TECHNICAL NOTE

LAND AT BURDELL ROAD, YAPTON, WEST SUSSEX RESIDENTIAL DEVELOPMENT

Client: Driftstone Homes Ltd
Reference: 6145

Date: July 2021

Drawing Status	FINAL		
Client	Driftstone Homes		
Project	Burndell Road, Yapton		
Drawing Title	Pedestrian Visibility Splays		
Scale	1:250	Date	July 21
Drawn By	SMO	Checked By	ALB
Drawing No.	2020-6145-005		Rev. C

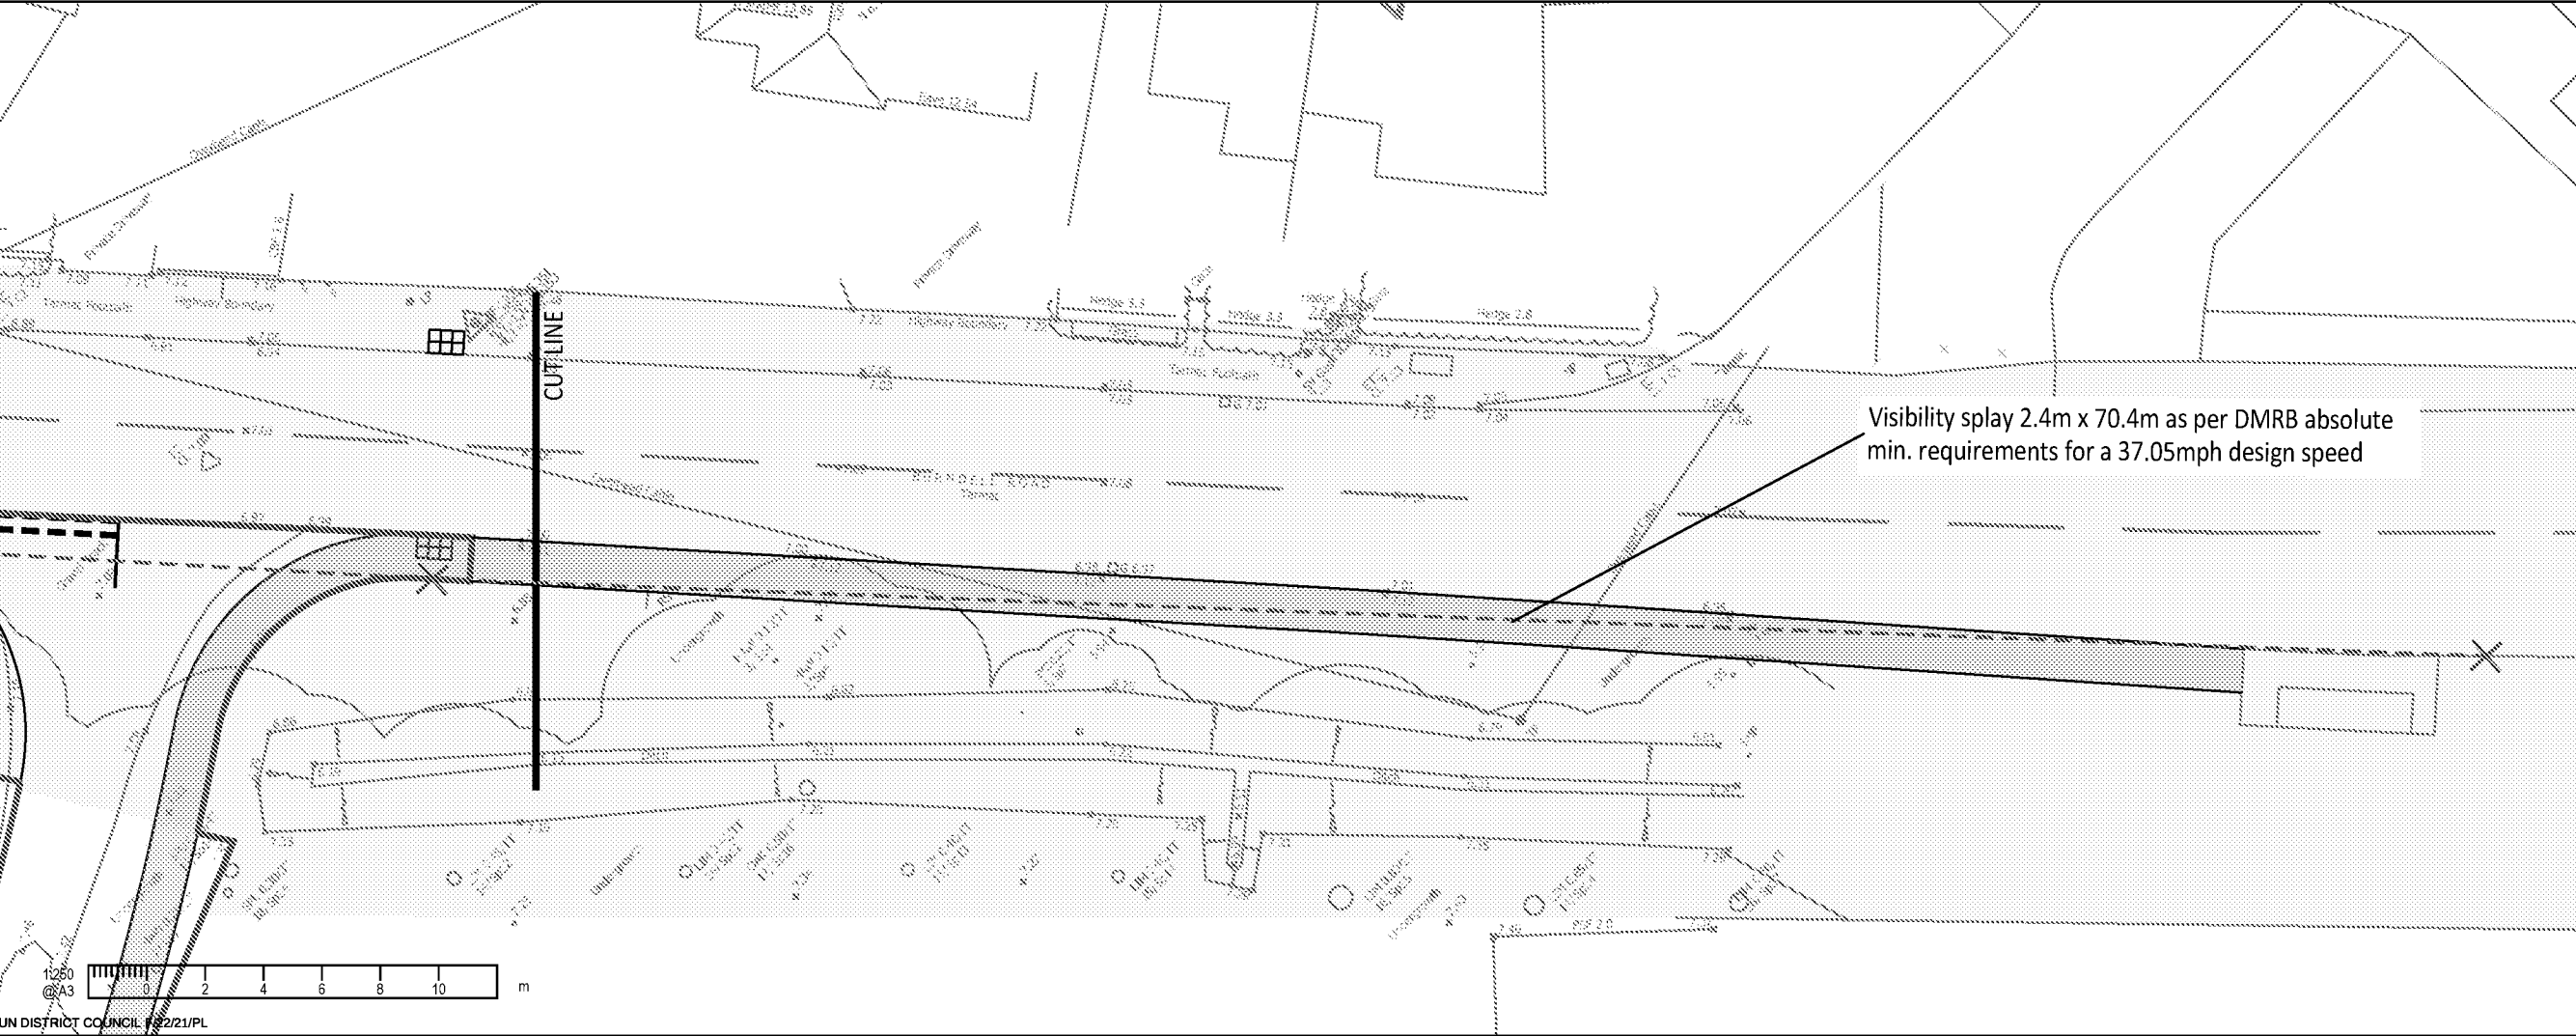
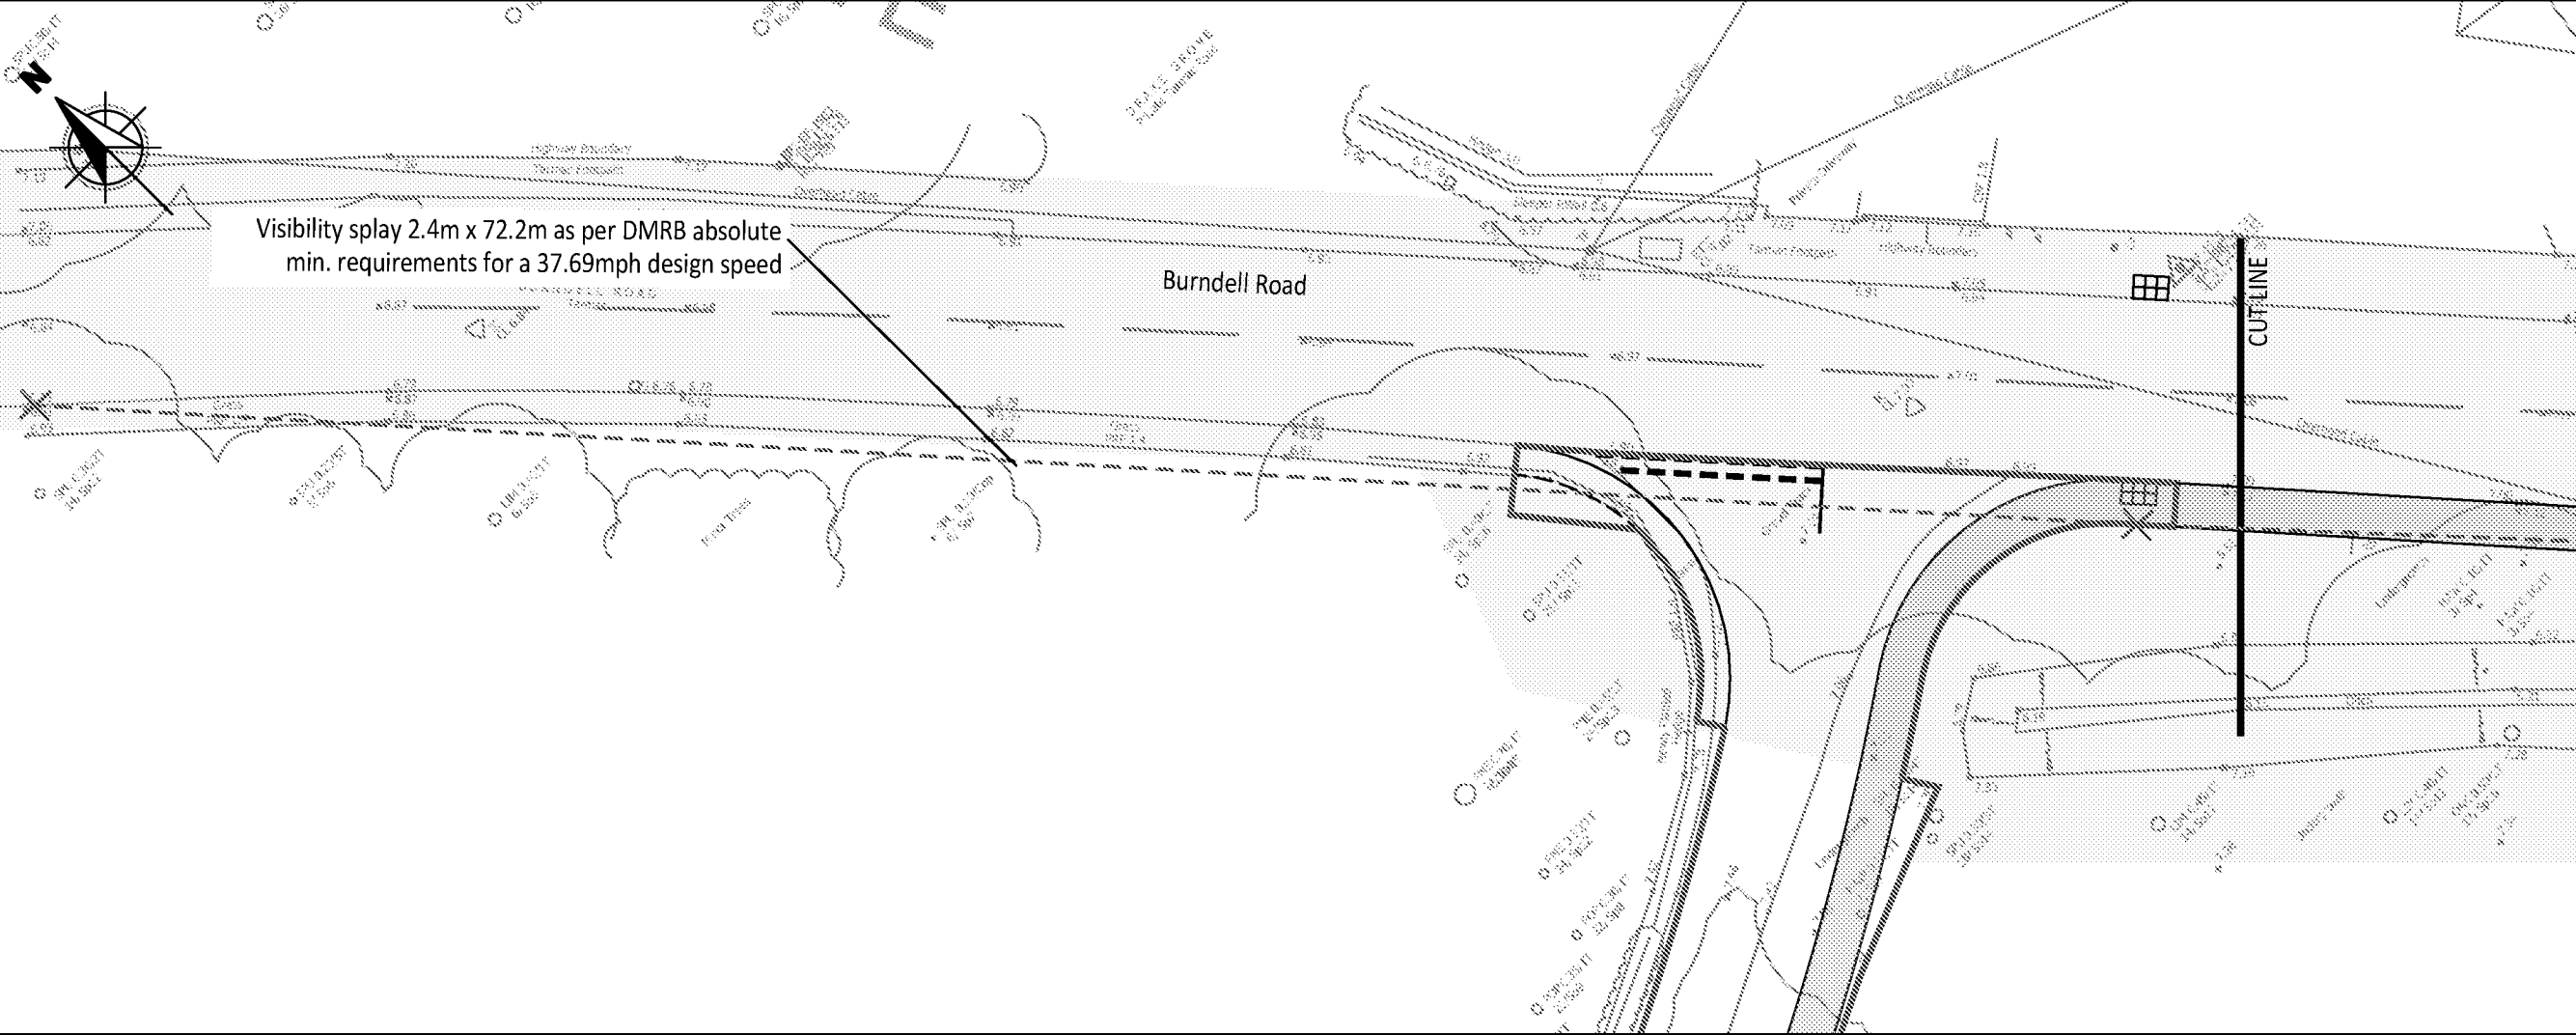
Location: B – Burndell Road south-east of the access junction (Dwg. 2020-6145-005 Rev. B)

Summary: Risk of pedestrian trips, falls and collisions with passing traffic.

The pedestrian visibility splays drawing shows that, 60m away from the proposed uncontrolled pedestrian crossing point on Burndell Road, there is a bus stop and shelter for north-westbound buses (photo 3).

Residents of, or visitors to, the new development, wishing to use the north-westbound bus route, will have to cross Burndell Road twice to do so, once using the new uncontrolled crossing at the new access junction, and again at the existing bus stop, where there are no dropped kerbs or tactile paving (photo 4).

It is more likely, however, that pedestrians will walk along the verge between the bus stop and the new development, risking trips and falls on the verge, or will walk in the carriageway when the verge is muddy, risking collisions with passing traffic.

The footway on the south-east shoulder of the development should be extended 60m to the existing north-westbound bus stop. This will also help safeguard the visibility splay south-eastwards from the development access junction (see problem 2.1 above).

- 2.2.4 Pedestrian visibility from crossings have also been demonstrated in accordance with the recorded 85th percentile design speeds with sight lines calculated using DMRB absolute minimum coefficients in **Drawing 2020-6145-005**.

- 2.3.2 An alternative betterment to the local footway network would however be offered in the form of a new footway to tie in with the 'Rollaston Park' bus stop to the southeast of the site. This additional infrastructure has been provided in accordance with the Stage 1 RSA recommendations.

Problem no.	Problem Accepted (yes/no)	Recommended Measure Accepted (yes/no)	Design Organisation Response	Over Seeing Organisation Response	Agreed RSA Action
2.1	Yes	Yes	All vegetation will be removed from within the visibility envelope. Vegetation to be replaced with grass to the north west and a 1.5m wide footway to the south east.	agreed	
2.2	Yes	Yes	The footway has been extended c.60m to the southeast to provide access to the existing bus stop.	agreed - noted improvement
